**Route 44 and
Grant Hill Road
Commercial Development
Coventry, Connecticut**

**EASTERN CONNECTICUT
ENVIRONMENTAL
REVIEW TEAM
REPORT**

Review Date: September 13, 1990

Report Date: October 1990

ARCHAEOLOGICAL SIGNIFICANCE MAP

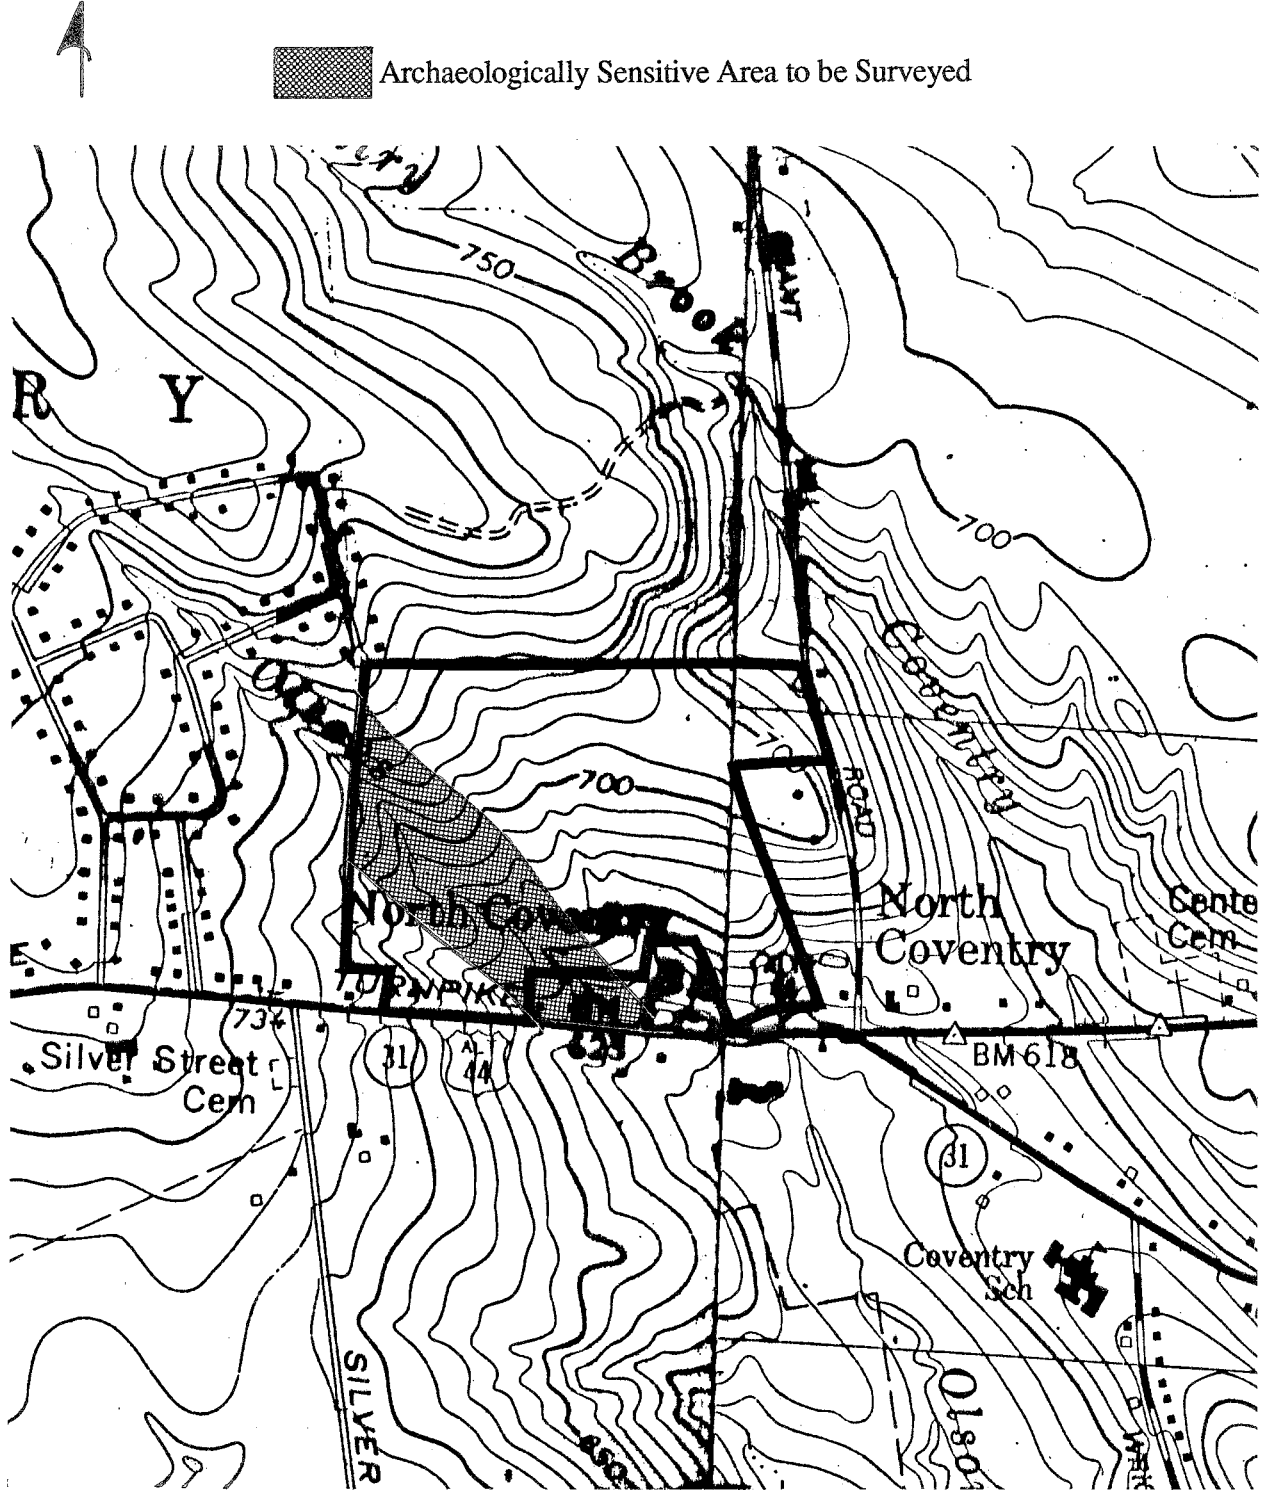
The Office of State Archaeology recommends that a reconnaissance survey be conducted on the project area along the corridor of Olson Brook. The enclosed map indicates the area of high archaeological potential. This survey should be conducted in accordance with the Connecticut Historical Commission's **Environmental Review Primer for Connecticut's Archaeological Resources**. The survey should locate and identify any cultural resources in the project area that may be effected by the proposed commercial development.

In summary, the Office of State Archaeology recommends an archaeological survey along Olson Brook within the project area to locate and identify prehistoric cultural resources prior to any construction activity. The Connecticut Historical Commission further recommend the maintenance of mature tree species to buffer the historic ambience of Route 44 buildings.
